MILITARY SPECIFICATION SHEET

ELECTRON TUBE, RADIATION COUNTER
TYPE 7840

This amendment forms a part of Military Specification Sheet MIL-E-1/1388C(EC), dated 19 July 1978.

"21. Starting voltage test circuit:

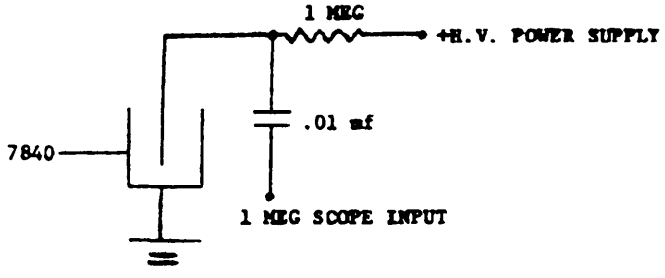
TABLE, METHOD 6211, NOTES column: Add ",20, 21".
